ADDENDUM NO. 1

RFQ CCC-078

**Administration Building Renovation
Compton Community College District**

tBP Project. No. 20987.00

110 4

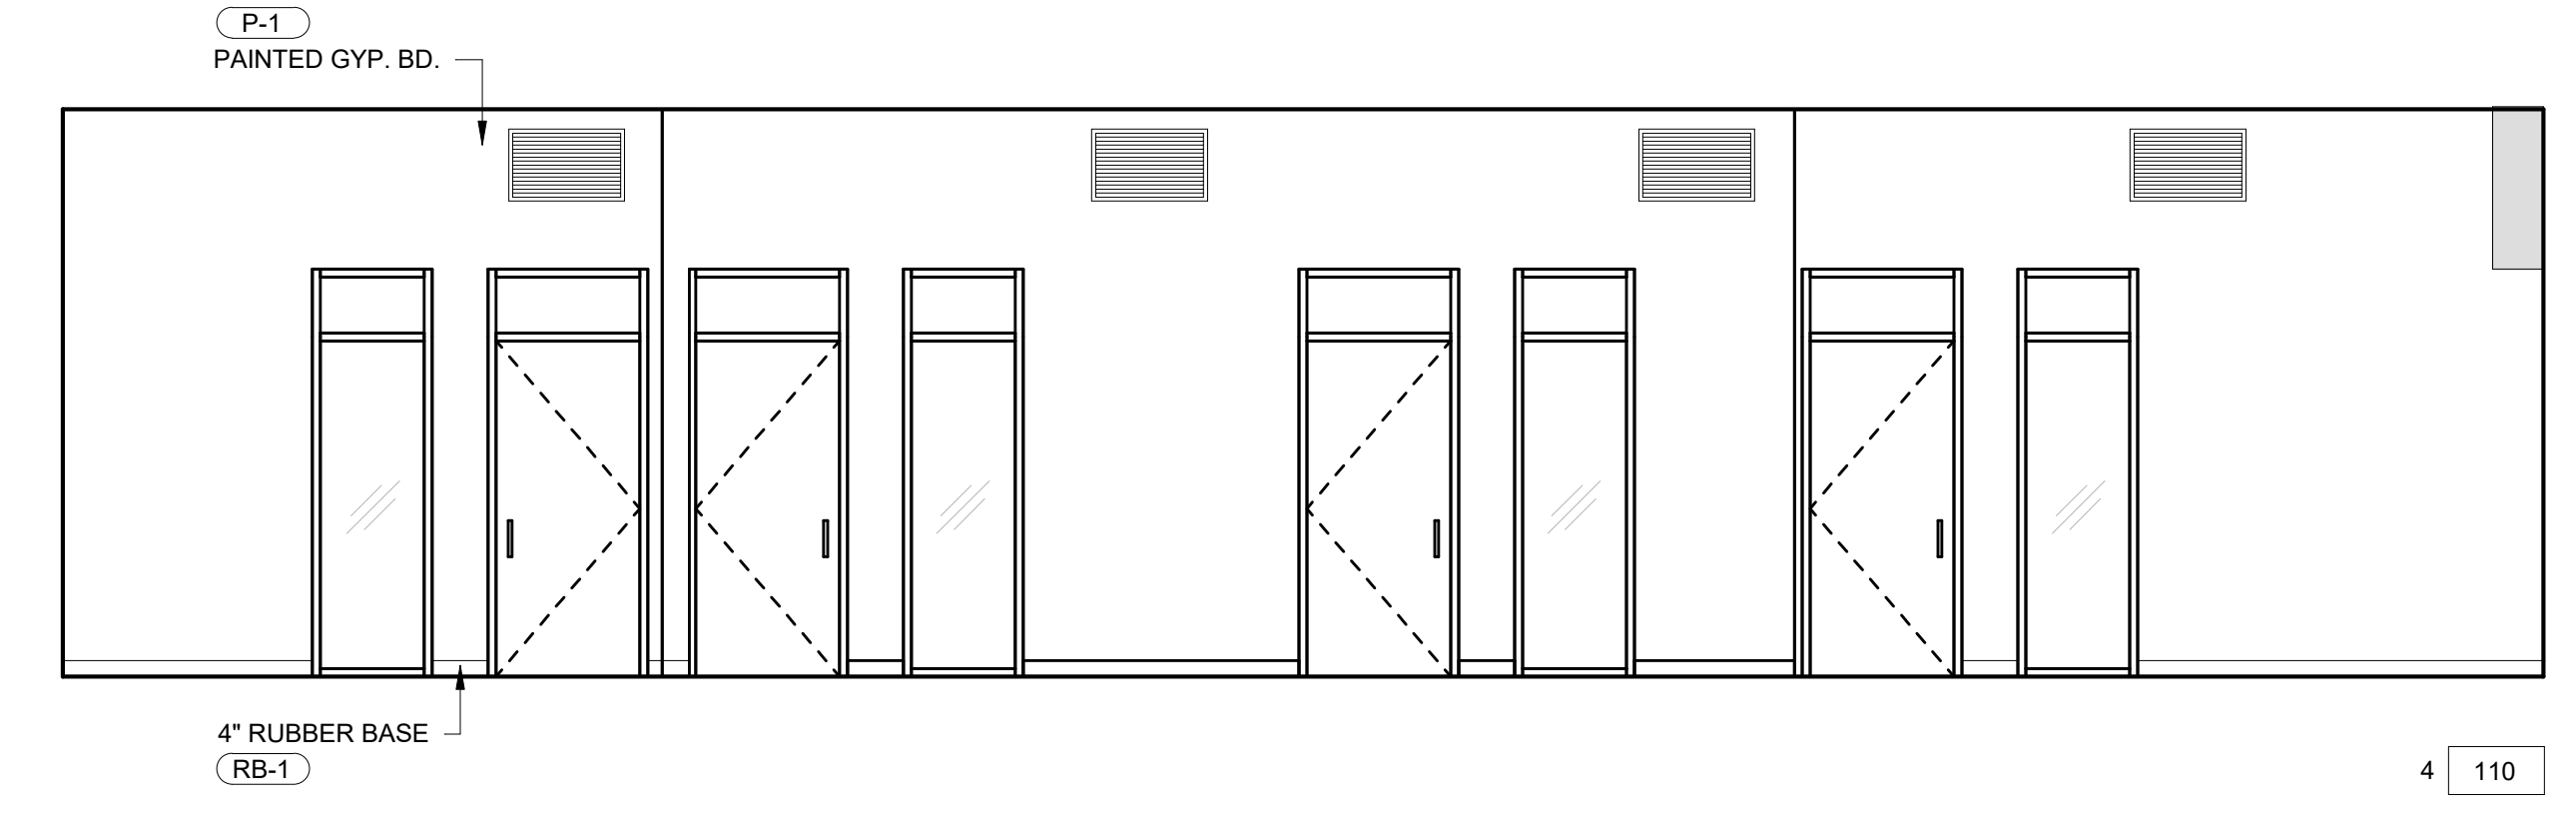
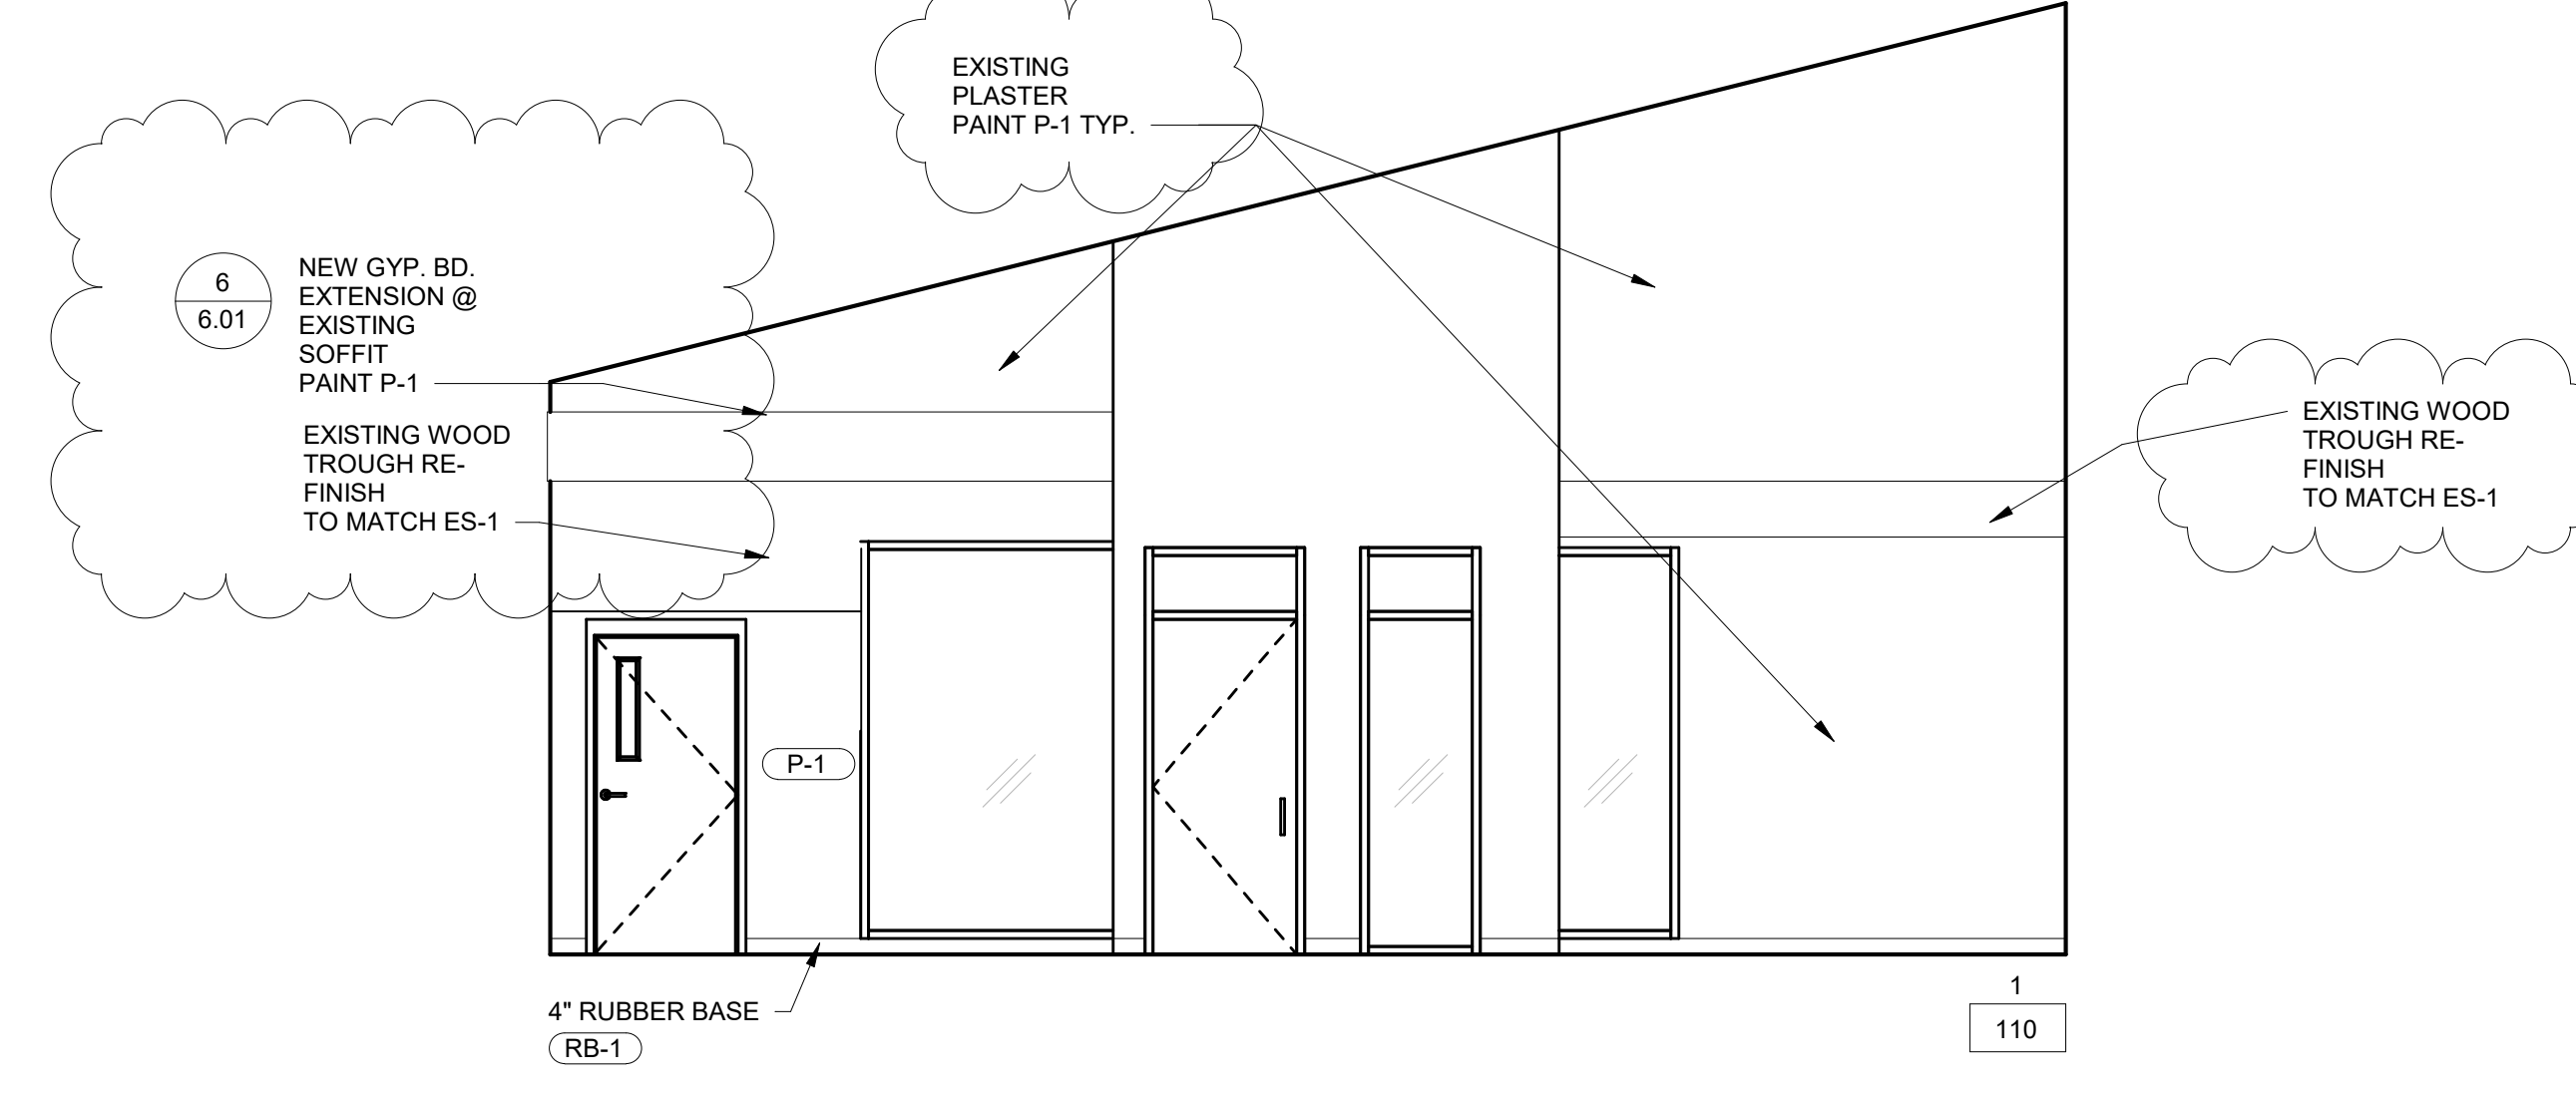
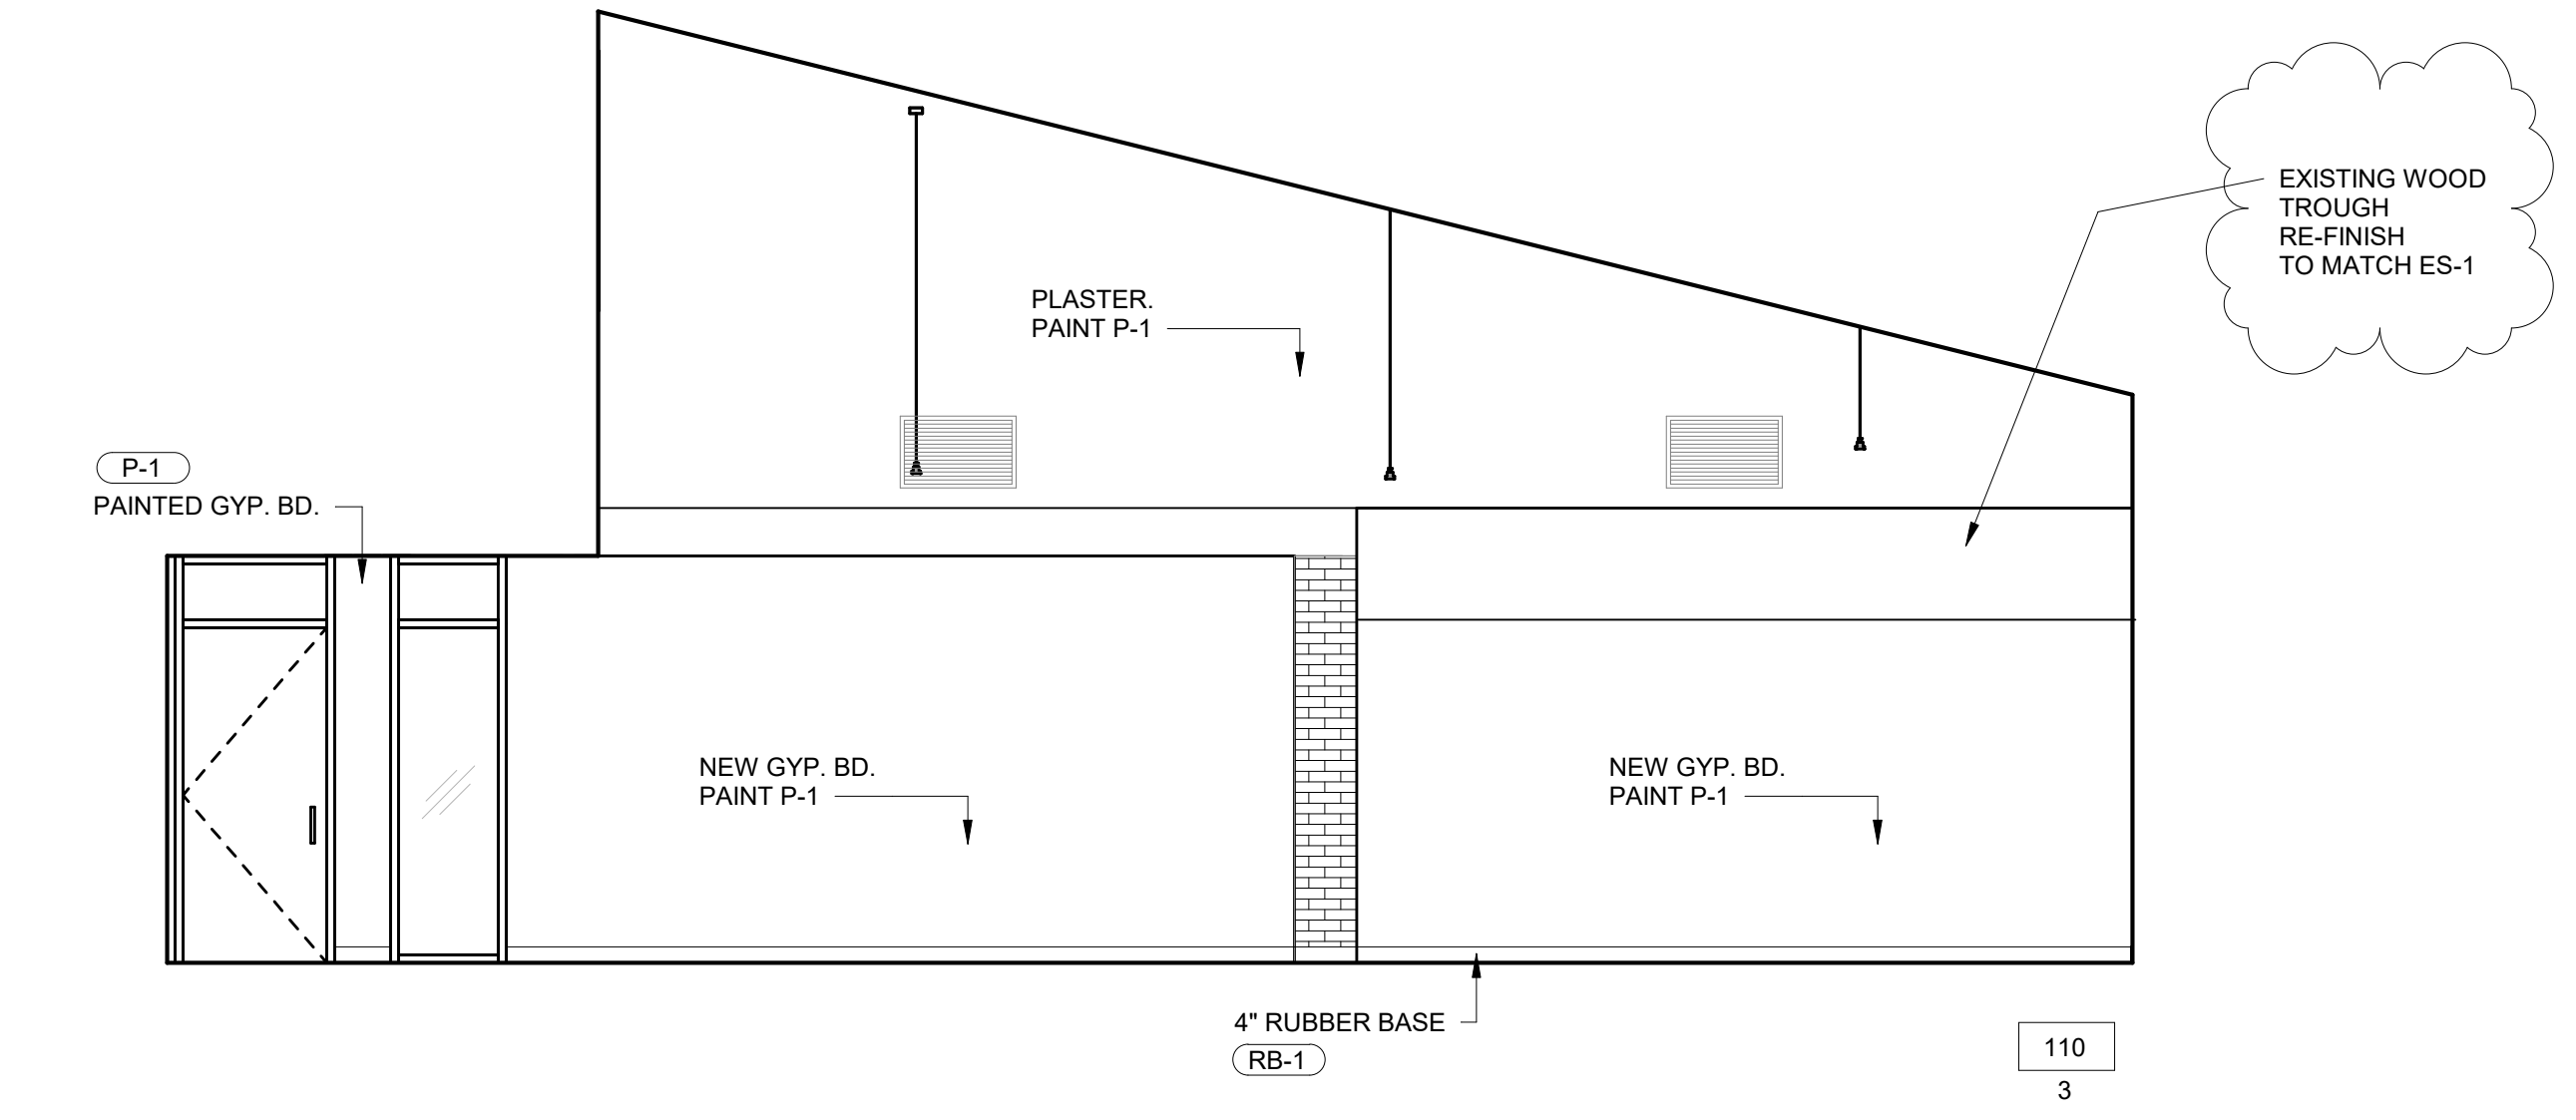
- b. Added finishes notes.
 - c. Removed crown molding and wood base and refinishing of wood paneling at Lobby.
 - d. Added soffit for duct at Open Office Room 110
See attached revised Full size sheet identifying revisions included as part of this addendum.

26 Revised Sheet E0-5 Lighting Fixture Schedule and Details.

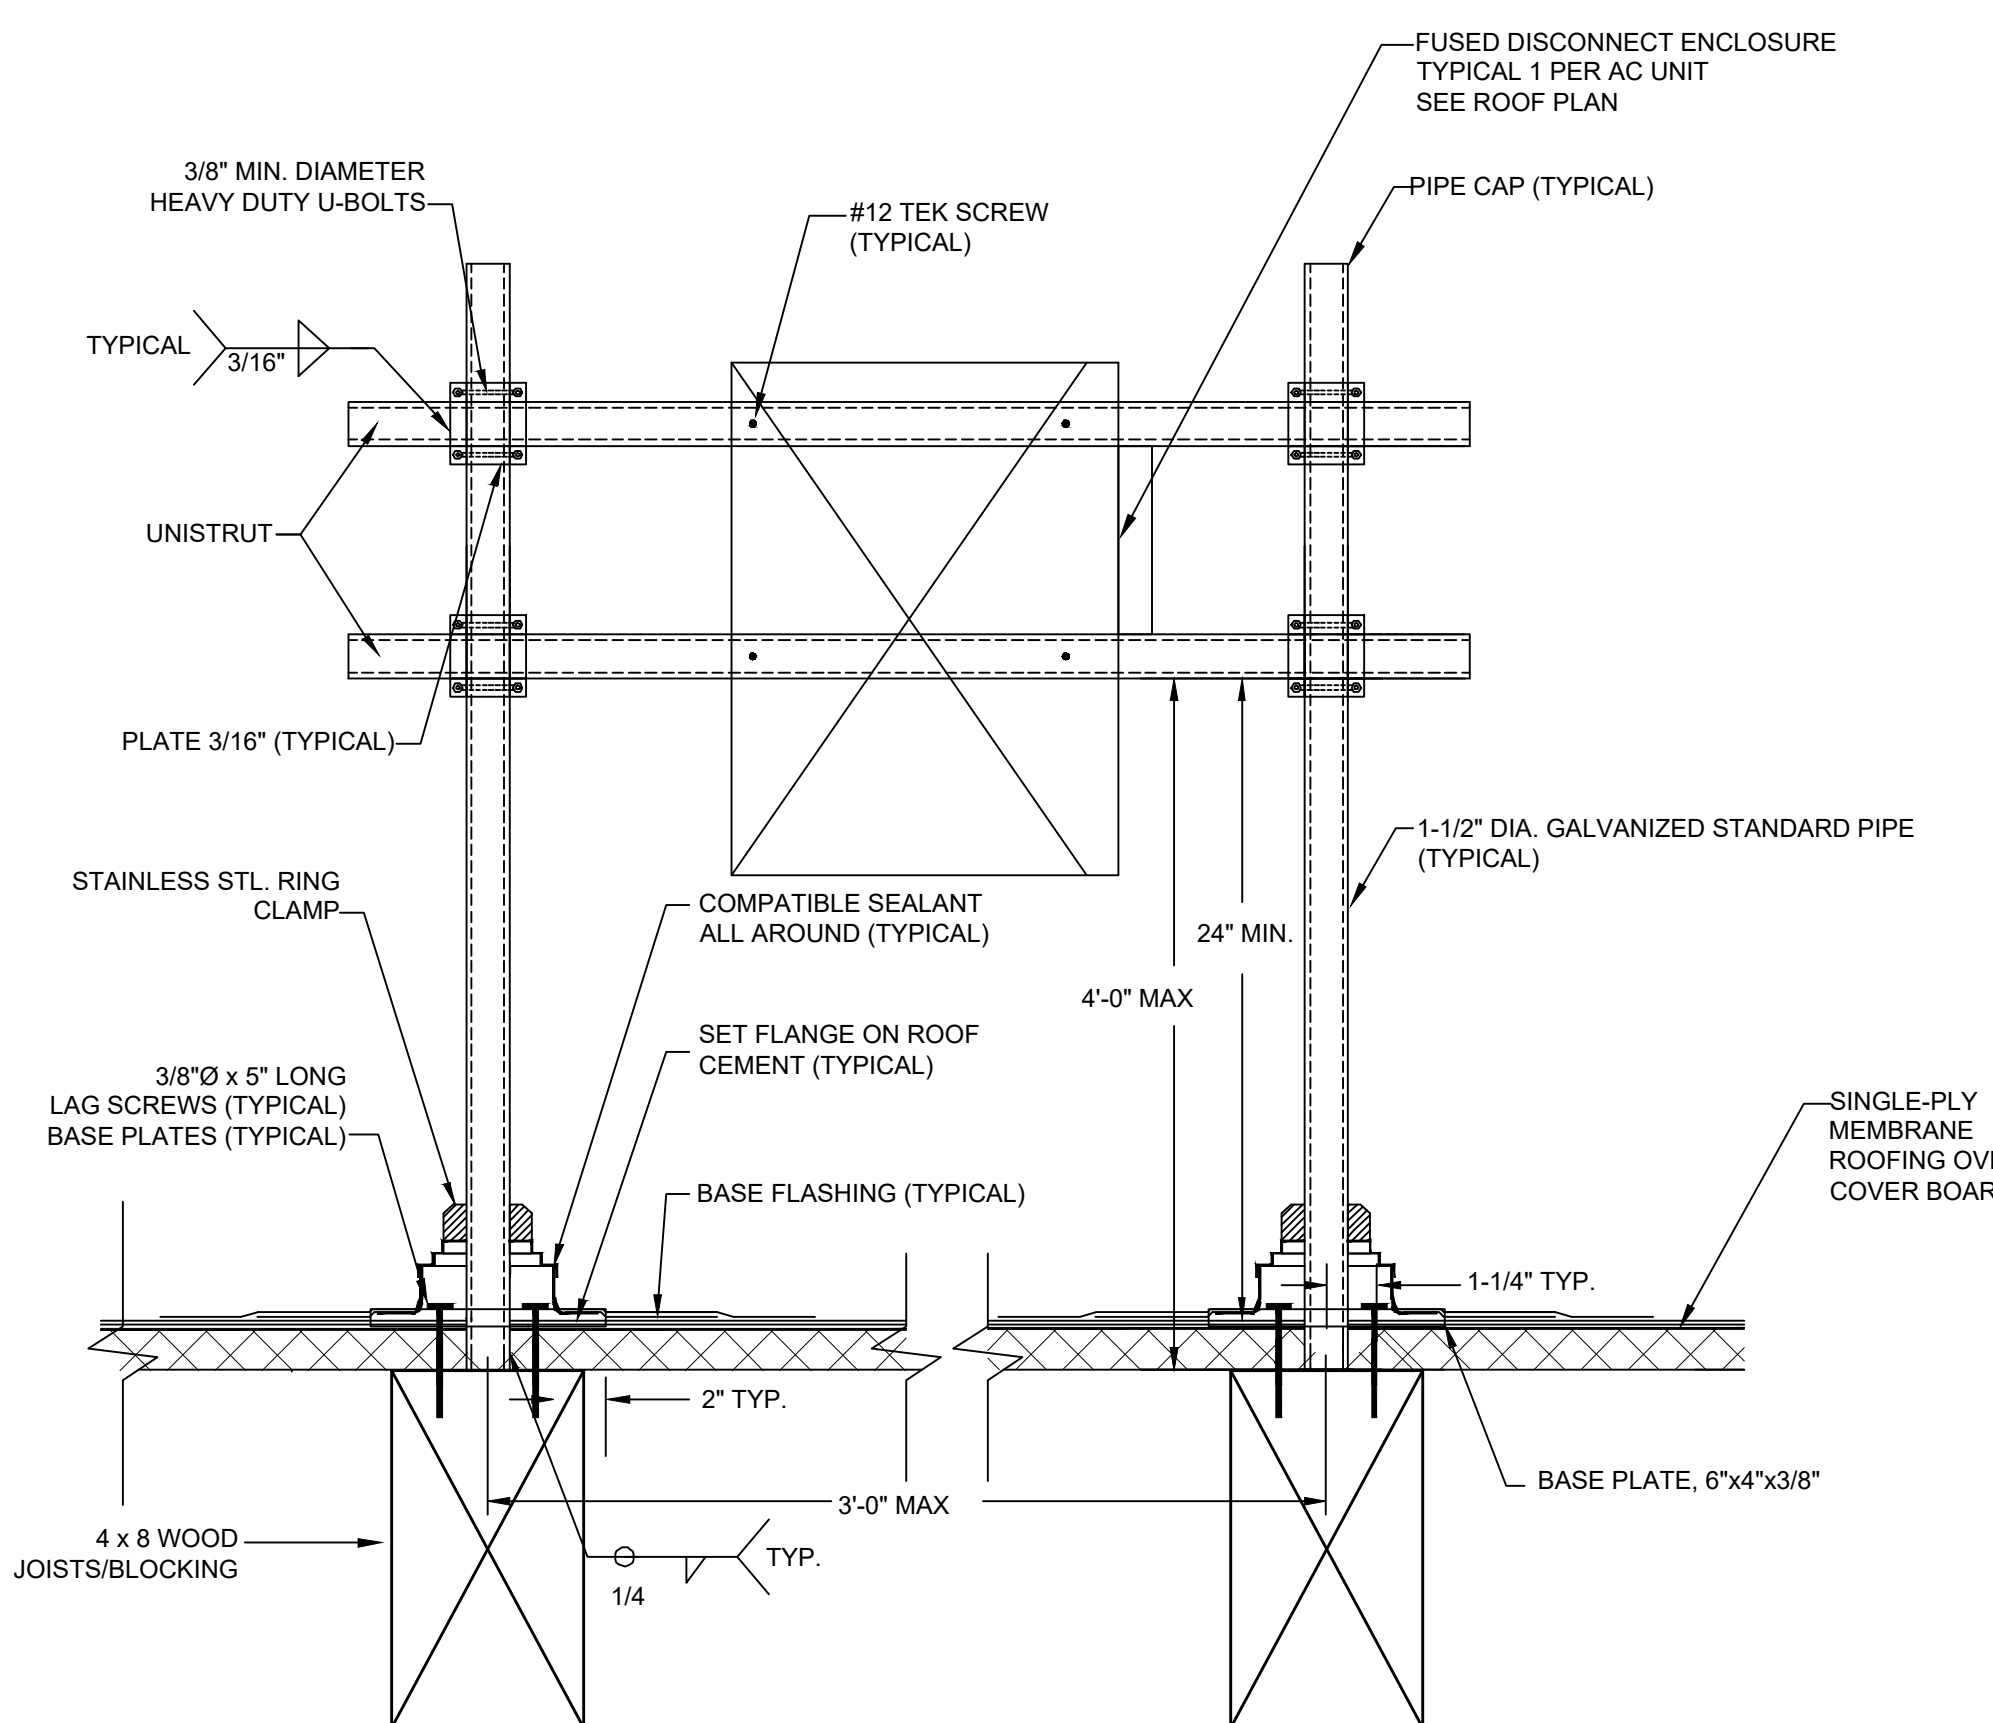
- a. Added schedule for Fixtures A2, D1, and X1.
- b. Added Details "C" for pad-mounted high voltage transformer and switch.
